Specific Site Assessment for Coal Combustion Waste Impoundments at Intermountain Generating Station

Delta, Utah

GEI Consultants, Inc.
4601 DTC Blvd., Suite 900
Denver, CO 80237

April 2011
Project 092884

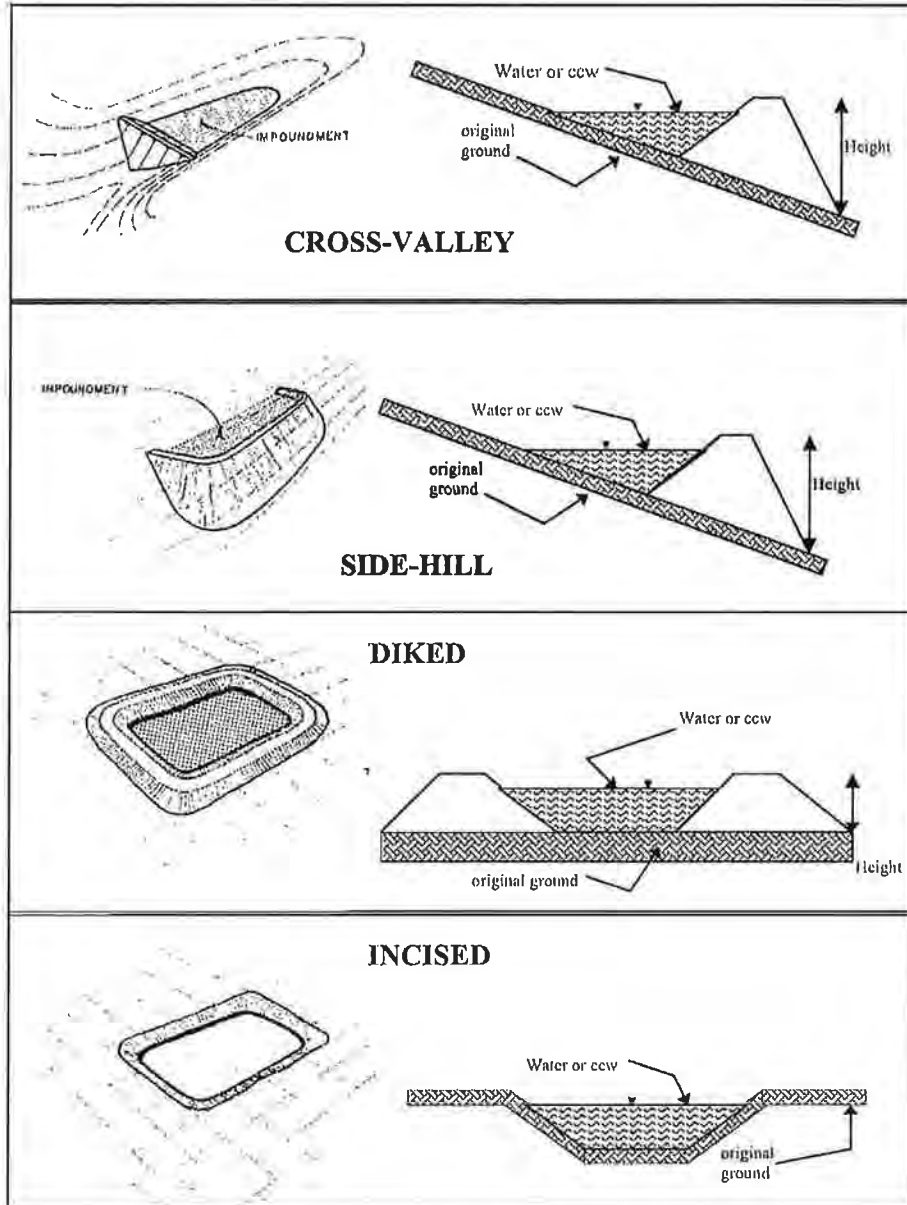
Inspection Issue #	Comments
12. No trashracks on intakes.	
16. Submerged outlet, could not observe.	
19. A few minor erosion gullies were observed along the east dike slopes.	19. Plant staff has an ongoing maintenance program to address these minor issues.
20. Water in receiving pond was clear, discharge submerged.

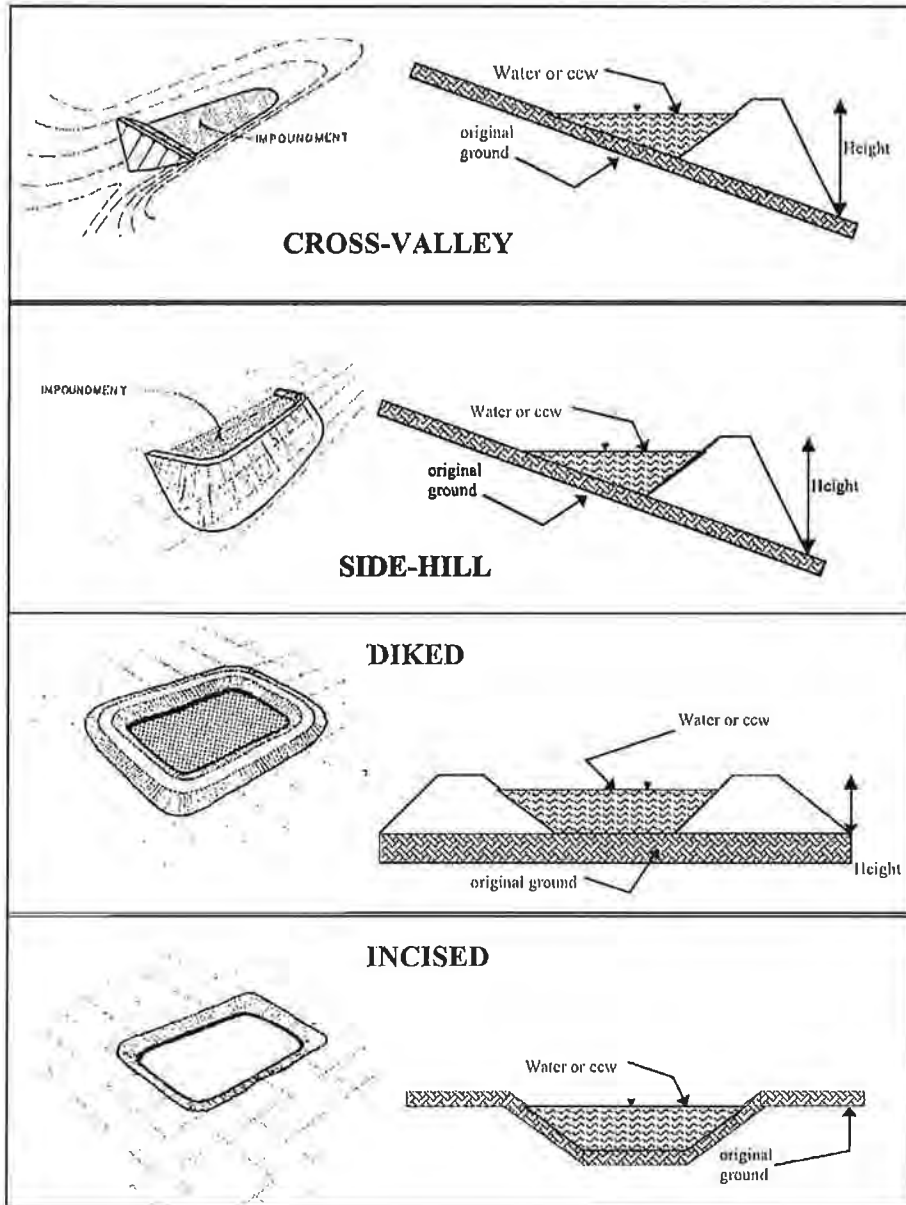
Inspection Issue #	Comments
12. No trashracks on intakes.	
16. Submerged outlet, could not observe.	
19. A few minor erosion gullies were observed along the west dike slopes.	19. Plant staff has an ongoing maintenance program to address these minor issues.
20. Water in receiving pond was clear, discharge submerged.

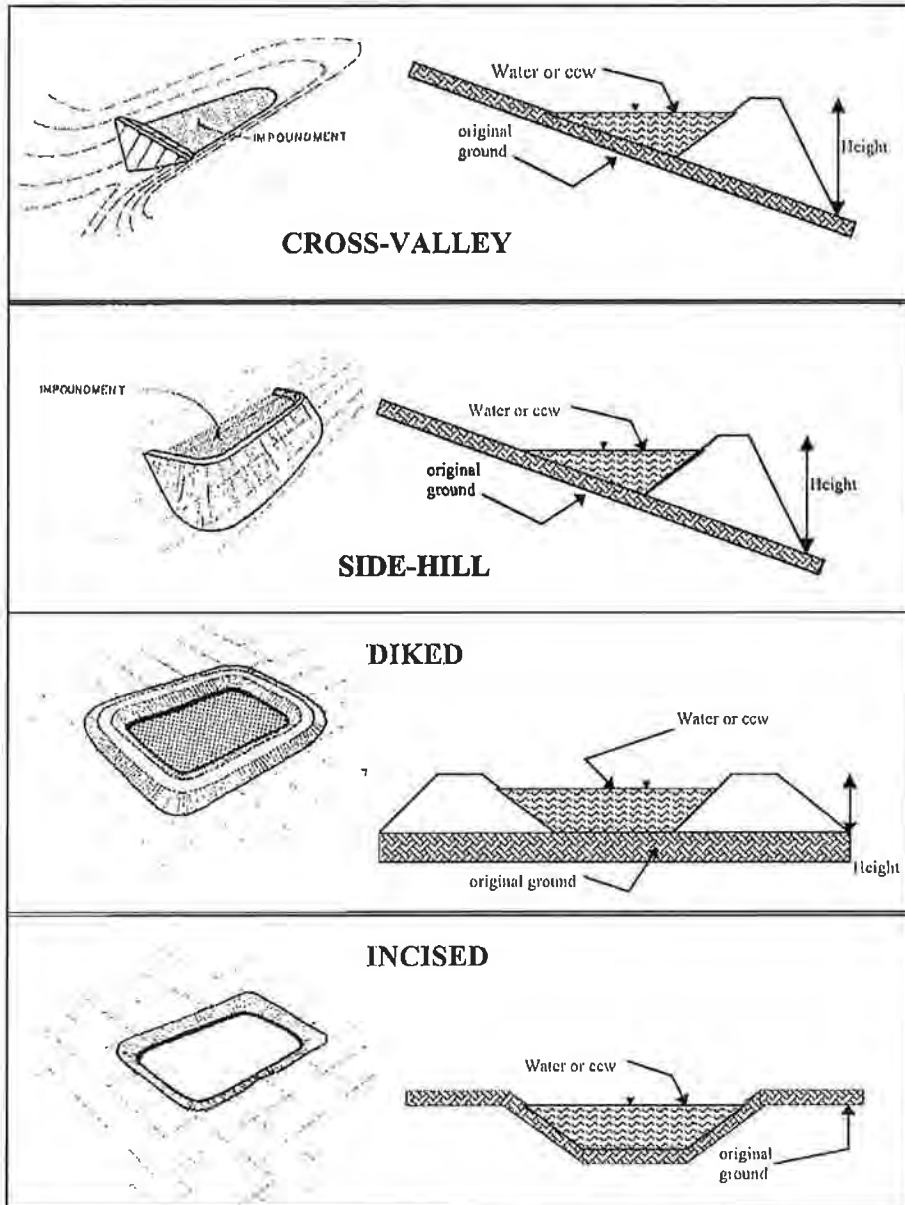
Inspection Issue #	Comments
16. Submerged outlet, could not observe.	
19. A few minor erosion gullies and a few abandoned small animal burrows were observed along the west dike slopes.	19. Plant staff has an ongoing maintenance program to address these minor issues.
20. Plant staff estimated flow through outlet to be about 200 gpm.
